Product Change Notice (PCN)

PCN Number: PCN-0539022R-01

Product(s) Affected: CBL-UA-P5-1

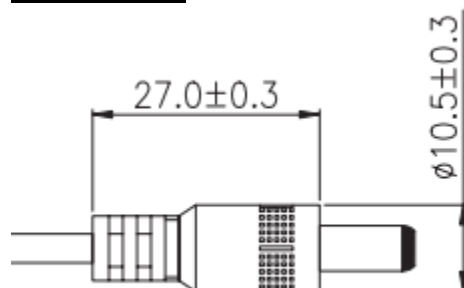
Reason(s) for Change: broken tooling for overmold.

Description of Change: dimension modifications to DC plug overmold as shown below:

Old design

New design
